INNER WEST

DEVELOPMENT ASSESSMENT REPORT

Application No.	MOD/2020/0401
Address	95 Ramsay Street HABERFIELD NSW 2045
Proposal	Modification of existing development to regularise works and inclusion of a dogwash facility
Date of Lodgement	11 November 2020
Applicant	Mr Victor Sahade
Owner	Haberfield Nominees NSW Pty Ltd
Number of Submissions	44
Value of works	\$775,850.00
Reason for determination at Planning Panel	Number of submissions exceeds officer delegation
Main Issues	Noise, parking, signage and stormwater
Recommendation	Approval with Conditions
Attachment A	Recommended modified conditions of consent
Attachment B	Plans of proposed development

PROJECT
CNR Ramsey & Kingston Streets
Haberfield
DRAWING
Signage Plan
Date
26/08/20
Scale
As Indicated
Author
WJF
Checked
WJF
Project Number
17/002
Drawing No. Rev No
A8.01

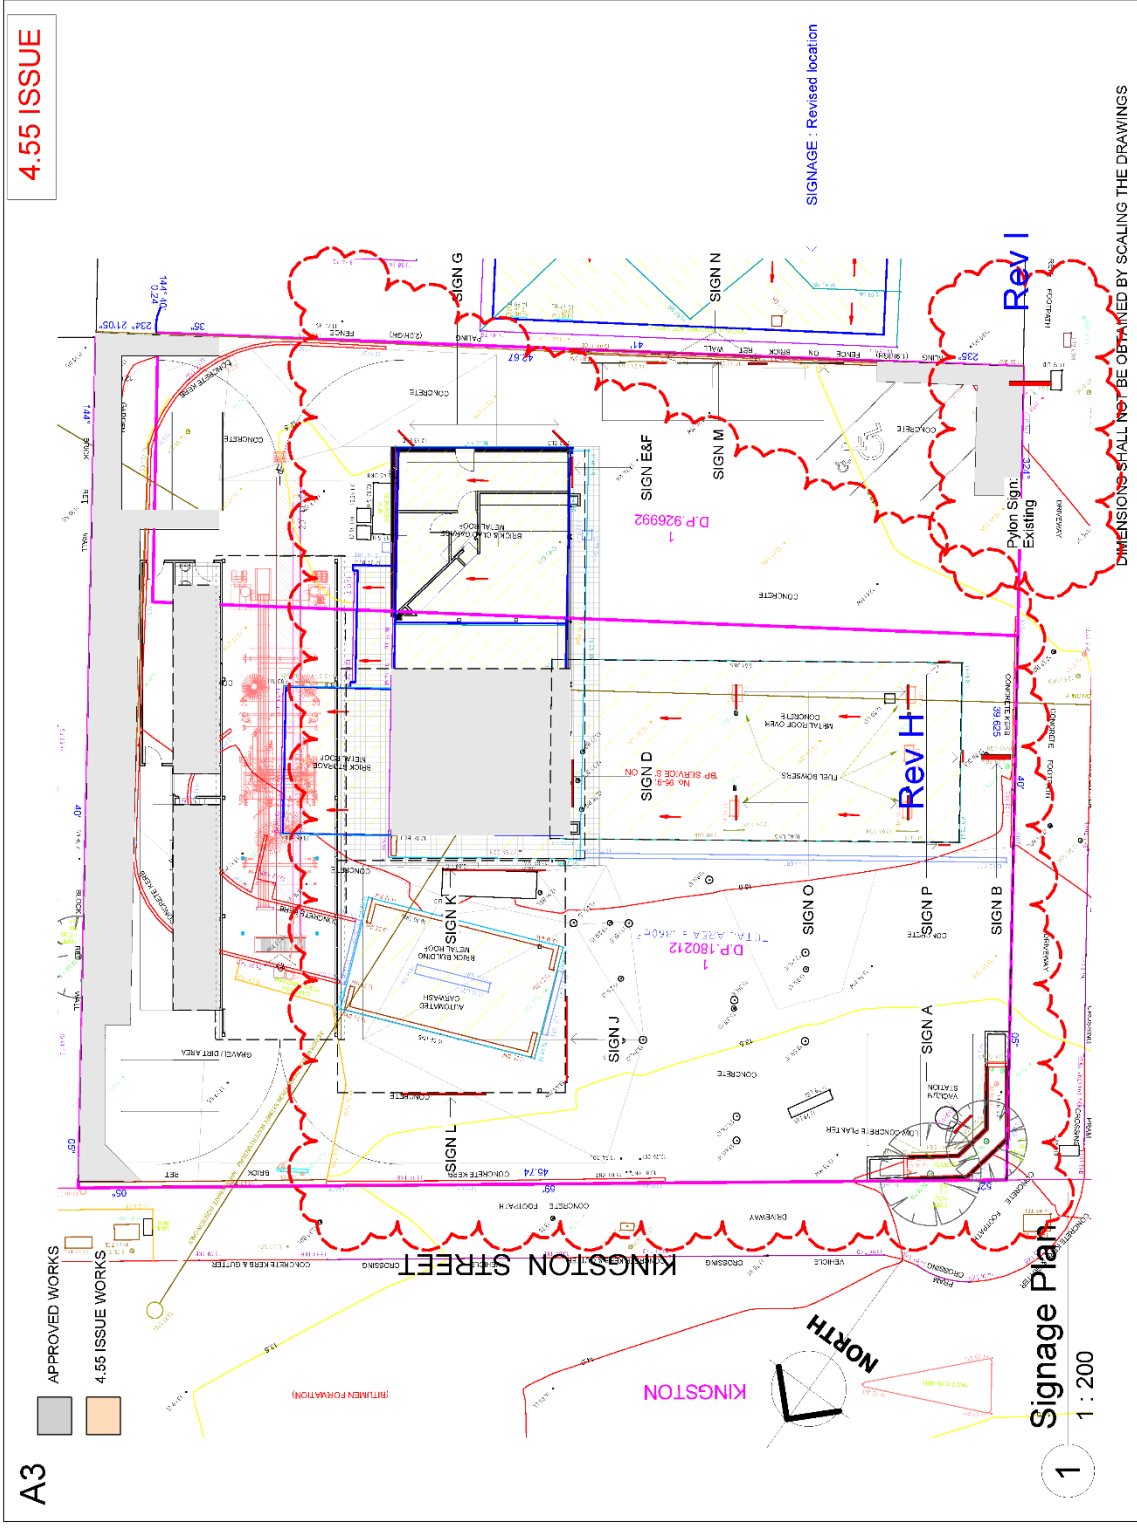
Having regard to the assessment criteria contained in Schedule 1 of SEPP 64, concern is raised that the signage proposed on the site is excessive and inconsistent with the character of the area and the streetscape. It is noted that the site adjoins low density residential development and is within the Haberfield Conservation Area. In particular, it is considered that Signs I, L & J are unnecessary given their positioning and proximity to similar signs and that the number of signs provided along the southern property boundary (Signs M & N) are excessive and unnecessary.

As such, a condition of consent has been imposed requiring Sign I, L & J be deleted, Sign M be amended to be one (1) sign only and Sign N be amended to be one (1) sign only. In addition, a condition of consent has been imposed requiring all illuminated signs be illuminated during the approved operating hours only.

- a) **Signs I, L and J as indicated on the approved plans be deleted;**
- b) **Sign M as indicated on the approved plans be amended to be one (1) sign only;**
- c) **Sign N as indicated on the approved plans be amended to be one (1) sign only; and**
- d) **The southernmost driveway on Ramsay Street be appropriately line marked as an exit only from the site.**
